ADDENDUM NO. 1

May 6, 2022

LIBERTY INTERMEDIATE SCHOOL ADDITIONS AND RENOVATIONS
Chesterton, IN 46304

This Addendum consists of Pages ADD 1-1 through ADD 1-3 and attached Addendum No. 1 from Gibraltar Design dated May 5, 2022 and consisting of 7 pages, Specification Section 07 53 25 - Single-Ply Roofing Rehabilitation, and 99 drawings.

SHEET
A,F,G
EL110

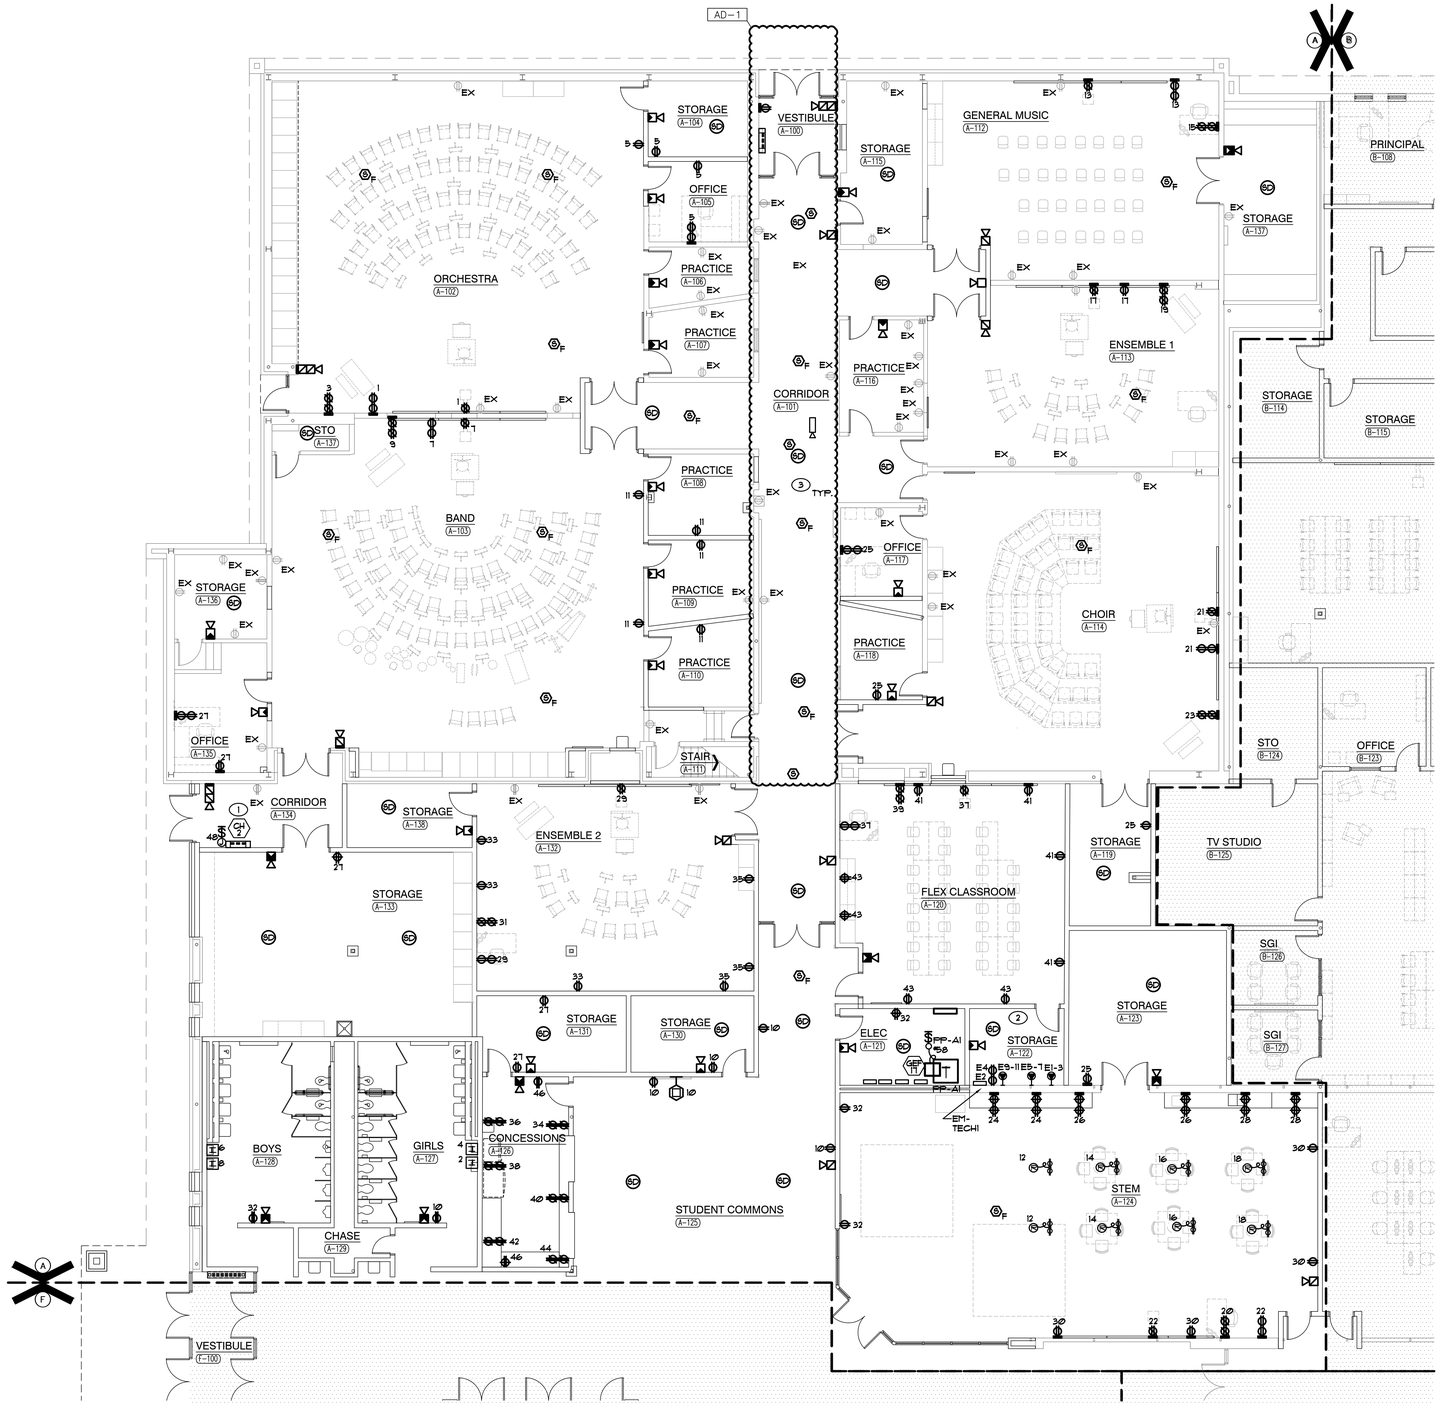
50. Sheet EL110

A. Refer to revised full-size drawing, included in this Addendum, for revised mezzanine with Exit sign.

SHEET
F
EP106

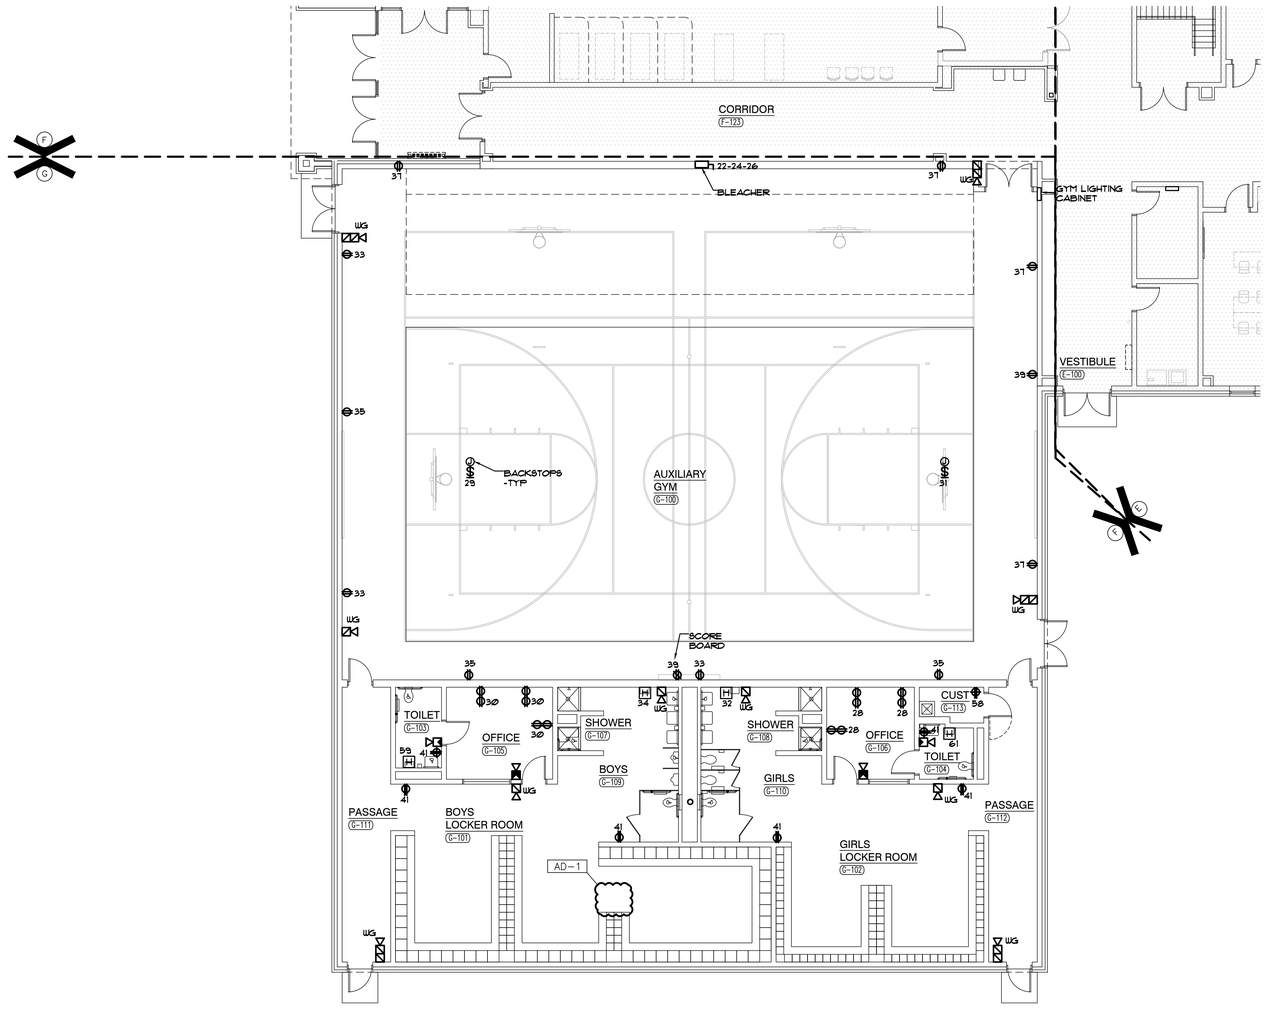
53. Sheet EP106

A. Refer to revised full-size drawing, included in this Addendum, for revised gym with new location for panels.

SHEET H EP108

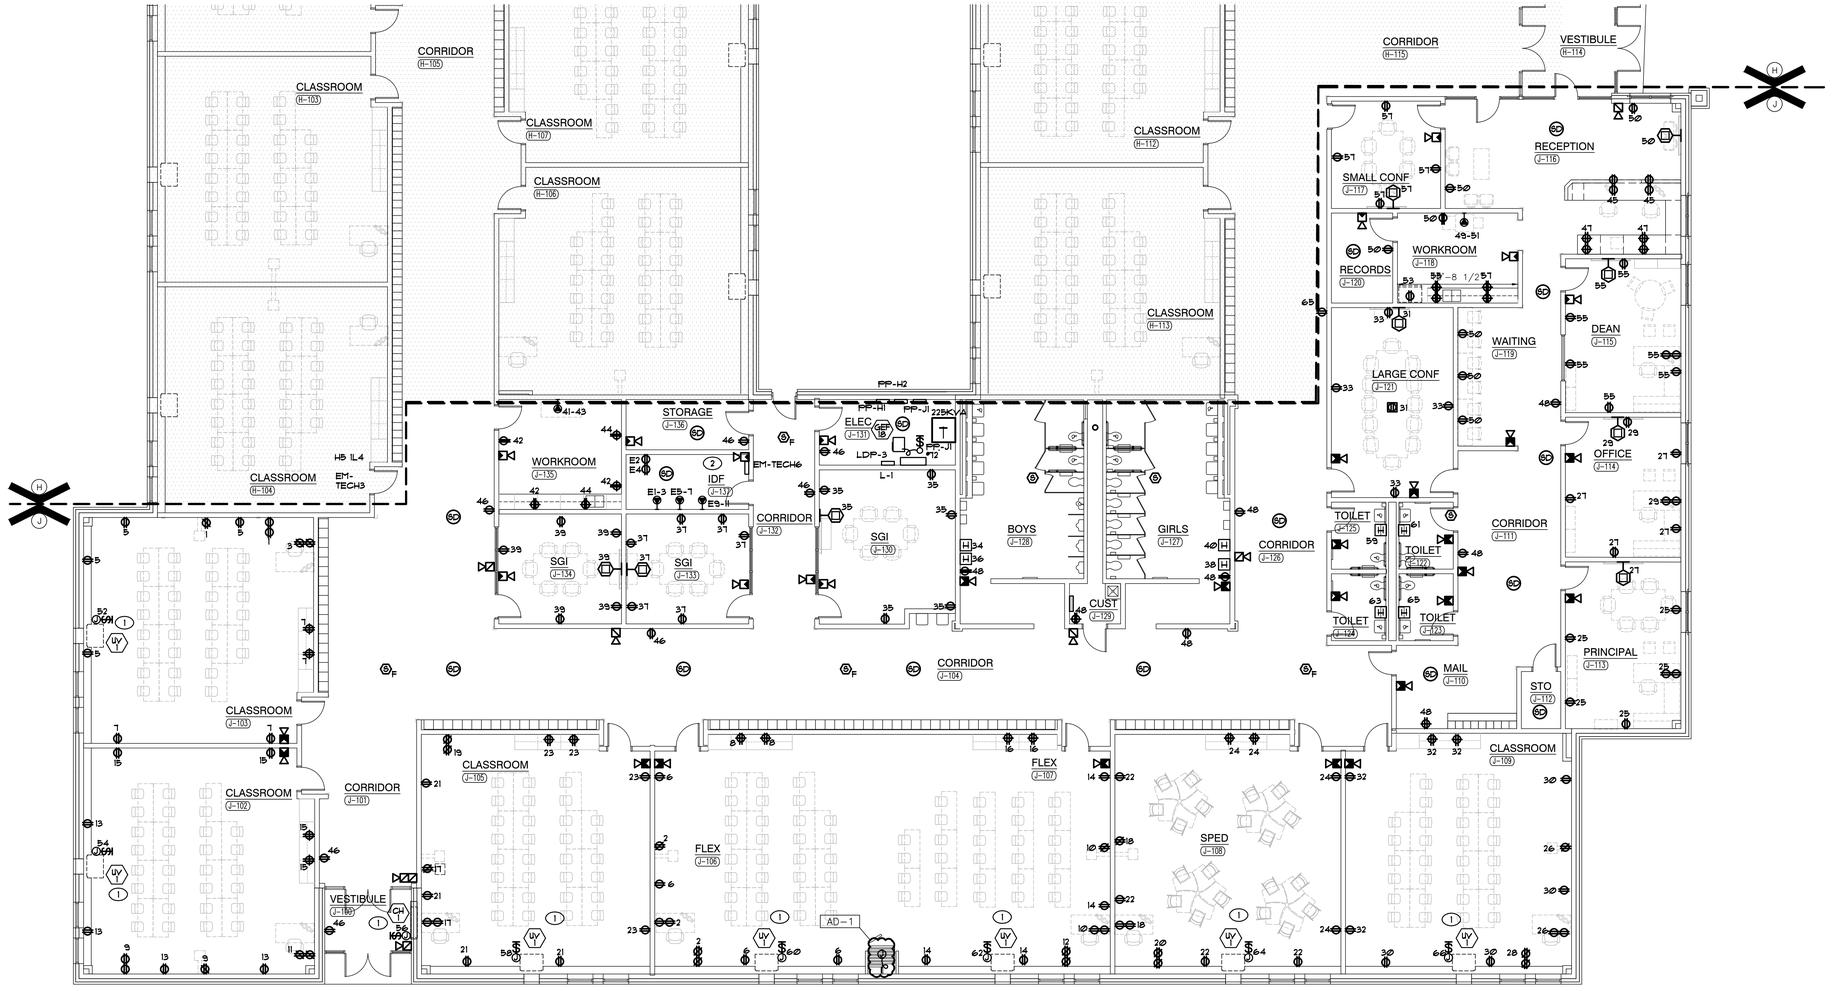
55. Sheet EP108

A. Refer to revised full-size drawing, included in this Addendum, for revised vestibule with ADA devices.

SHEET
A,F,G
EP110

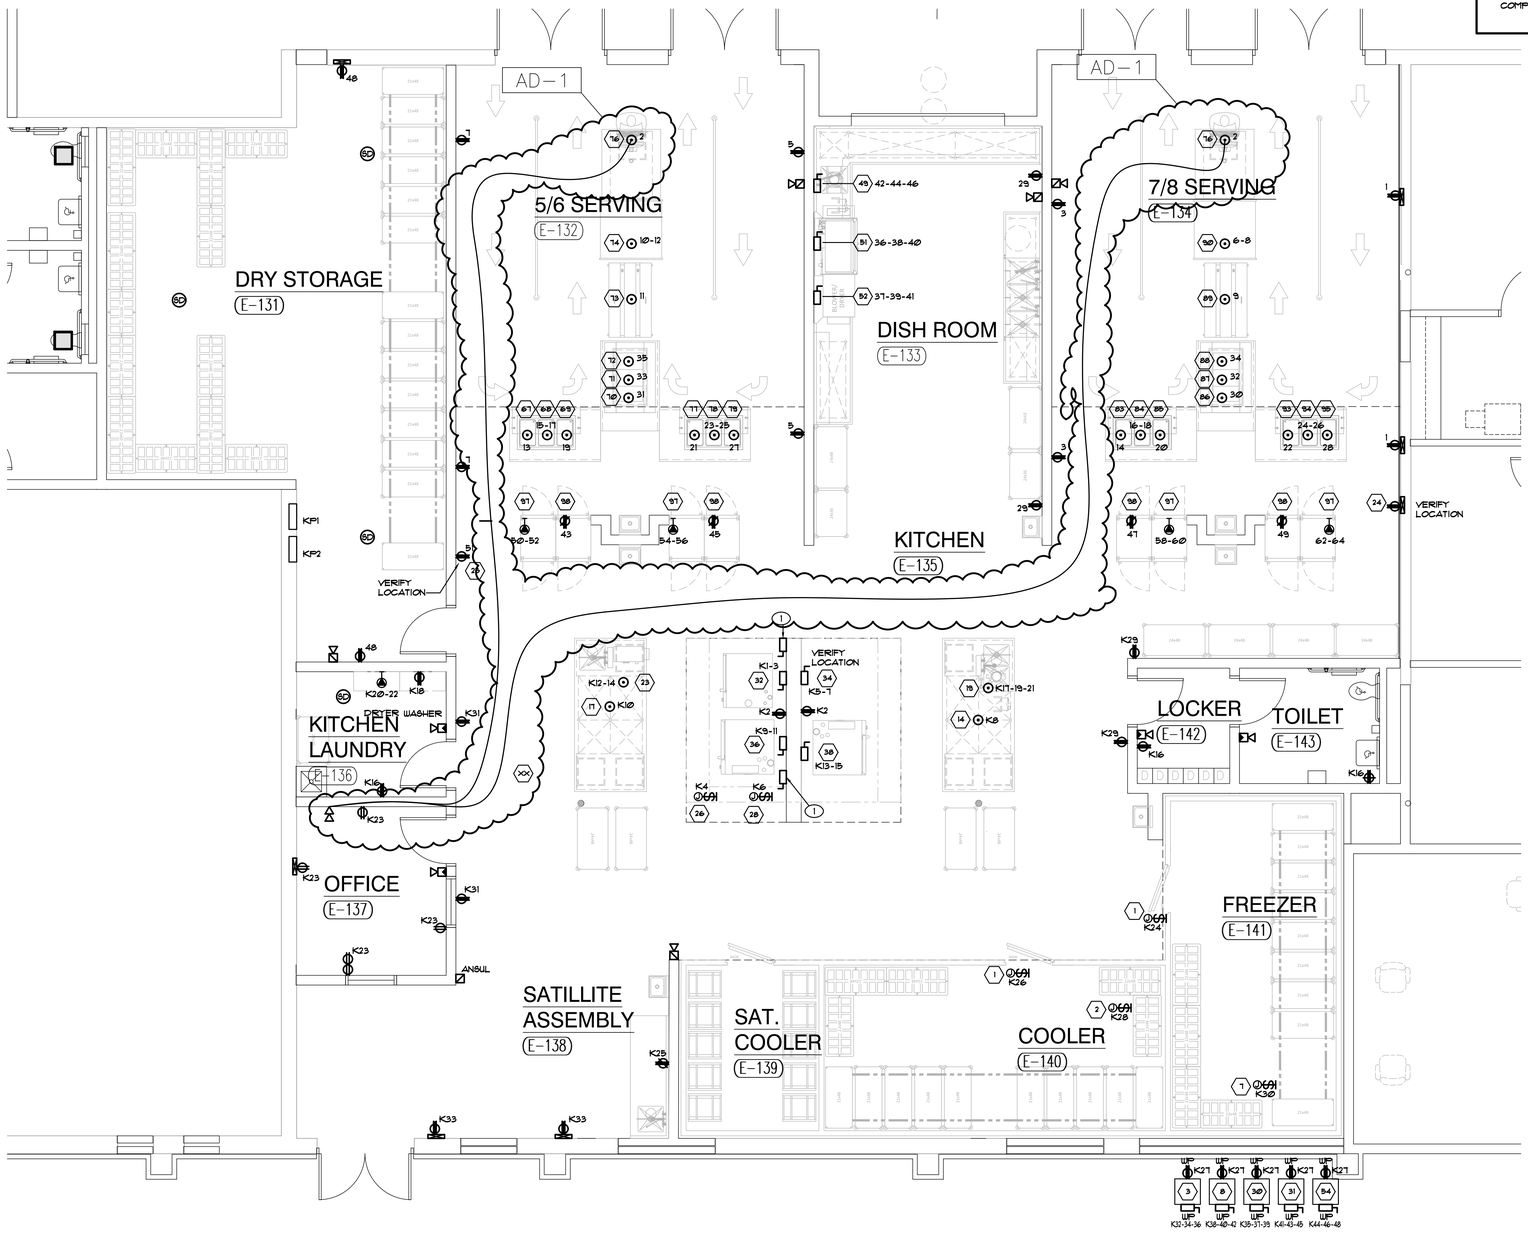
57. Sheet EP110

A. Refer to revised full-size drawing, included in this Addendum, for revised fire alarm.
